**VILLAGE OF WAUNAKEE/TOWN OF WESTPORT  
JOINT PLAN COMMISSION  
Town of Westport Community Room  
5387 Mary Lake Road  
August 15, 2017 - 6:00 PM**

**AGENDA ITEM:** Discuss and Take Action on concept plan for Lot 2 of CSM 14255, Kilkenny Commons

Re: Animart Conceptual Site Plan–Kilkenny Commons

Drawing Name  
Site Plan

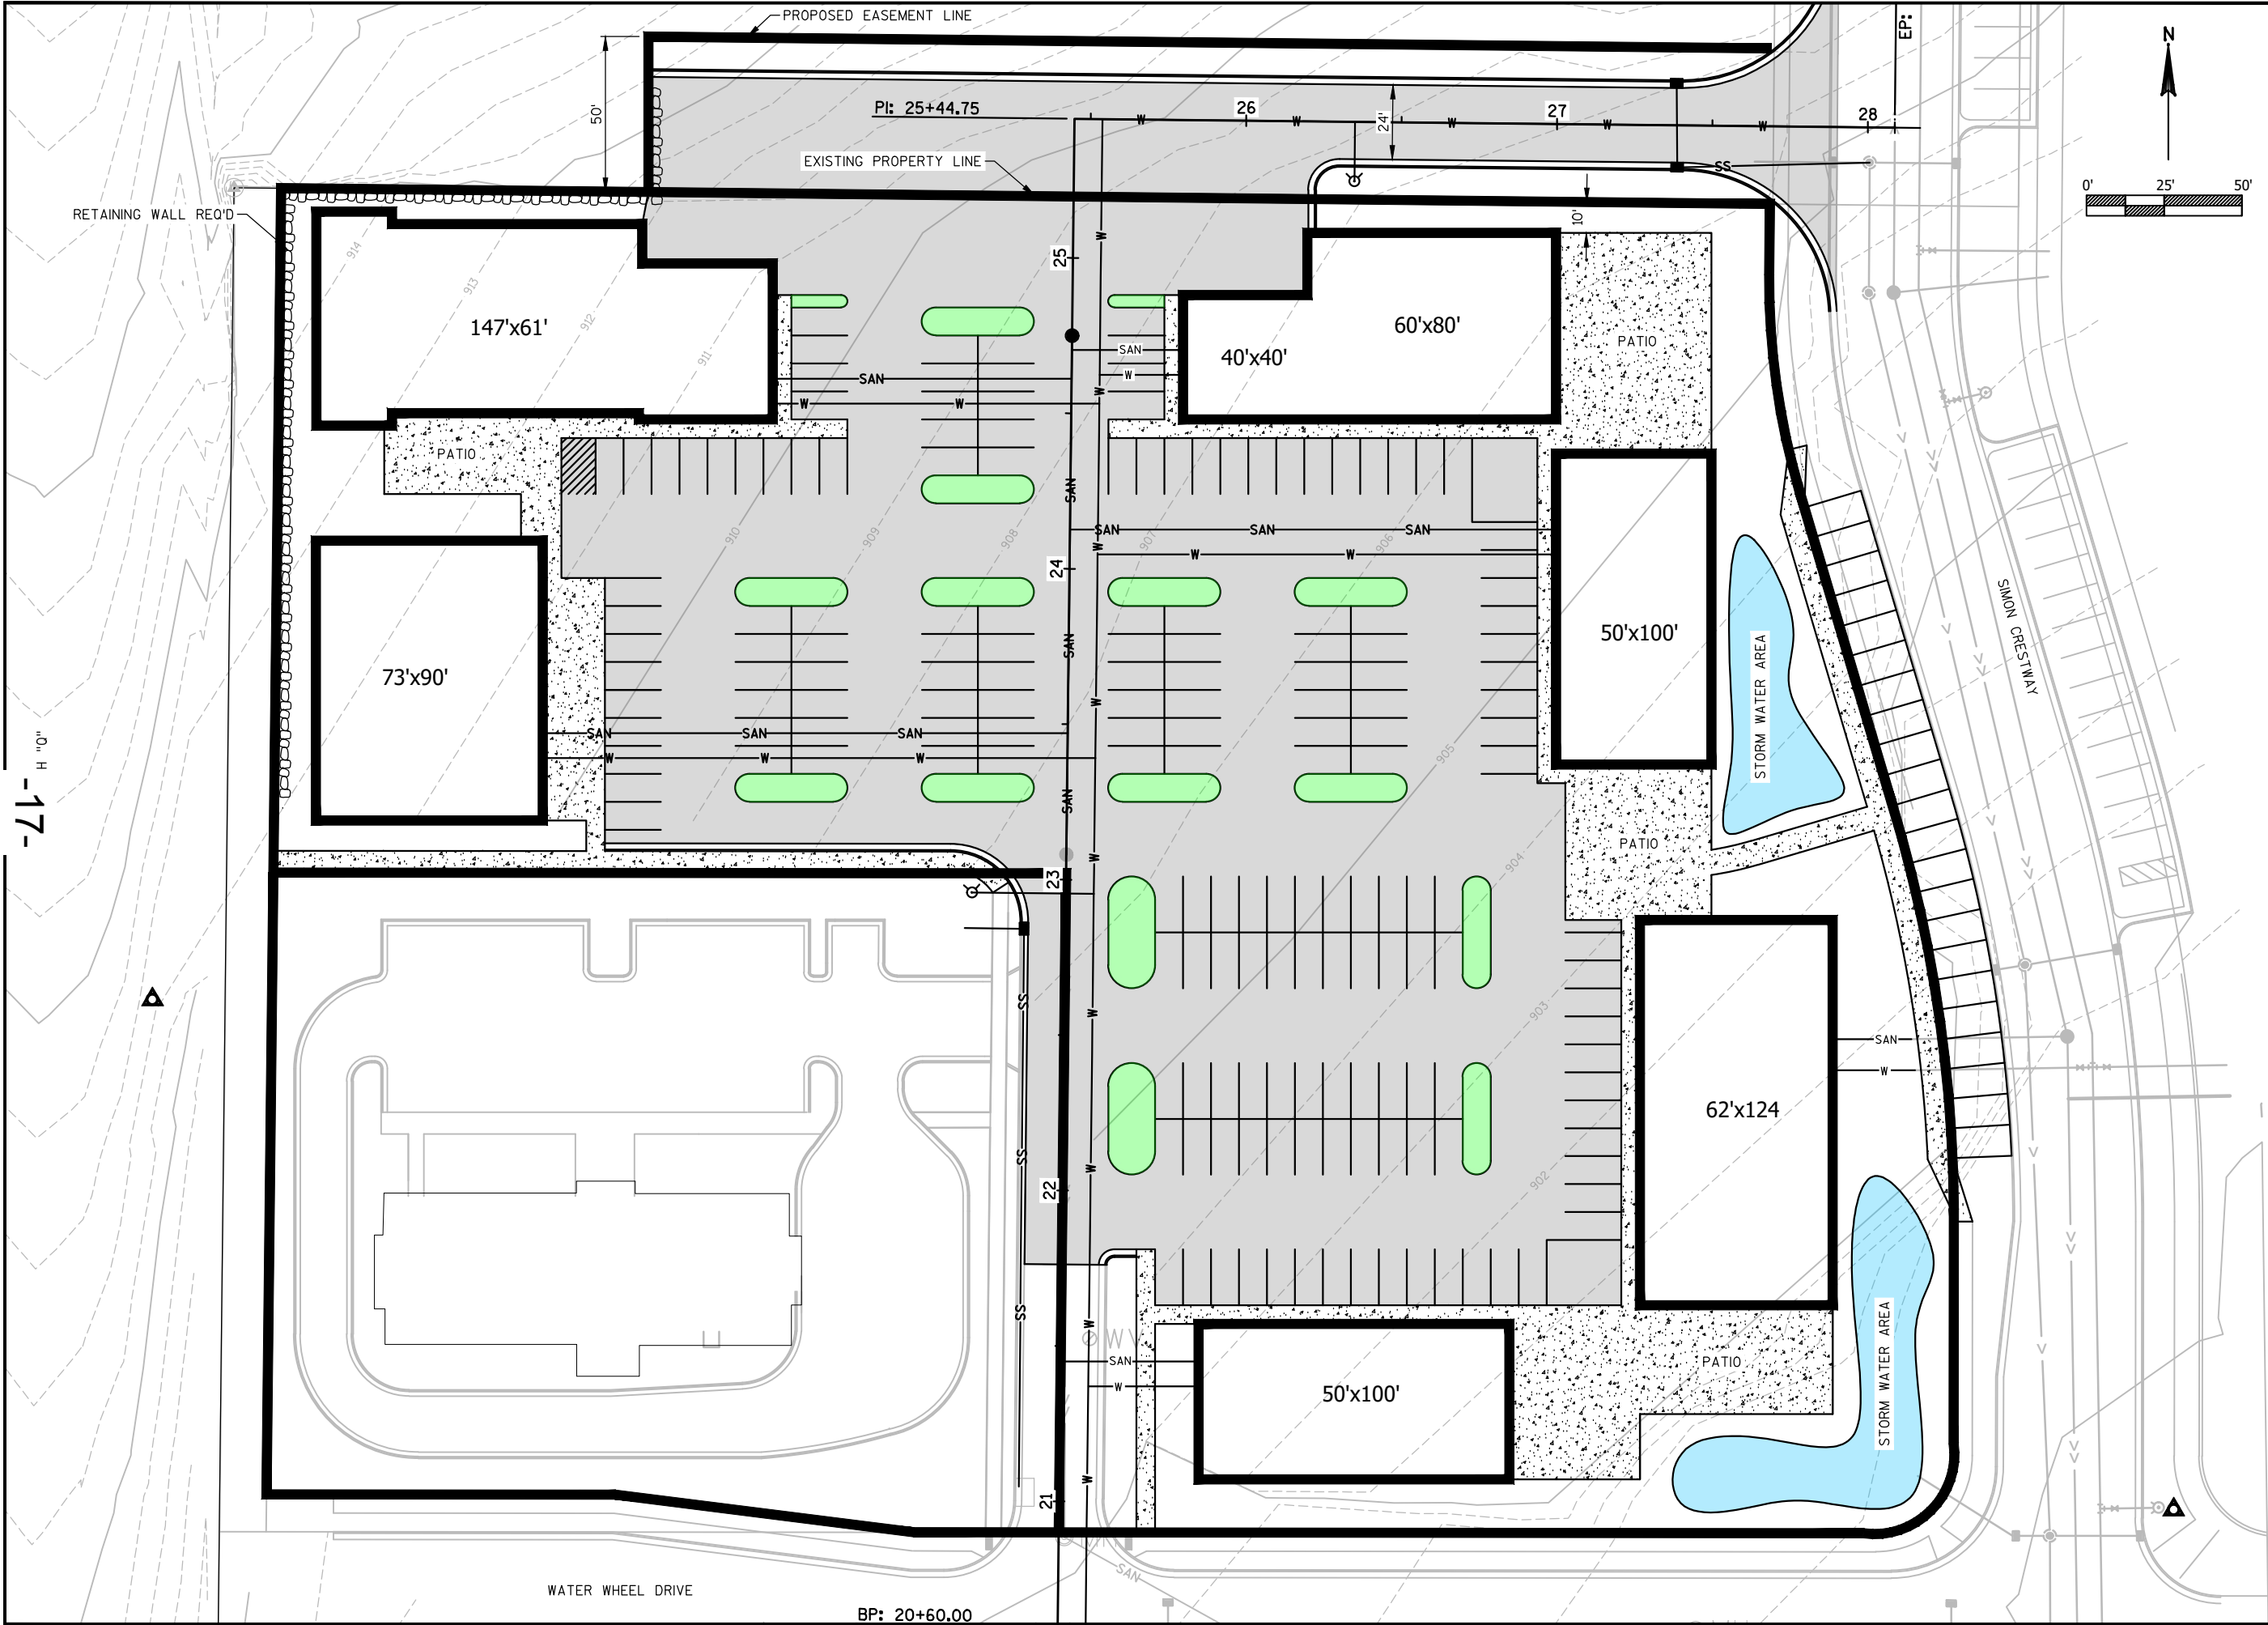
Jewel Associates provided a conceptual layout dated July 14, 2017 of proposed buildings within the remainder of Kilkenny Commons for review. A follow up sketch was provided by SEH, dated July 19, 2017, which modified the Jewel Plan. The applicant driving the conceptual review is considering the building at the northwest corner of the site, which is intended to house Animart pet store and a pharmacy. Our following comments are related to elements of both site plans.

1. As established when the bank was constructed at the southwest corner of the overall site, the sewer and water utilities will be considered public utilities, and are constructed within easements provided to the village.

2. The SEH plan appears to provide approximately one stall per 235 square feet of floor space, assuming there is no second floor space considered in the totals. This value falls within the range required by ordinance for retail and office spaces. Therefore, the conceptual parking layout seems reasonable.

3. There are no dumpster spaces shown; we presume the applicant will have to add one or more common waste disposal area on the site, unless each unit is intended to have its own smaller containers.

4. Space for storm water infiltration is shown on the plan. The applicant should demonstrate the adequacy of the spaces to serve the needs. In the location shown in the SEH plan, the proposed pond may not be able to serve all the buildings without significant piping.

5. The parking stalls along Simon Crestway, perpendicular to the direction of travel, are not conducive to safe travel along the street.
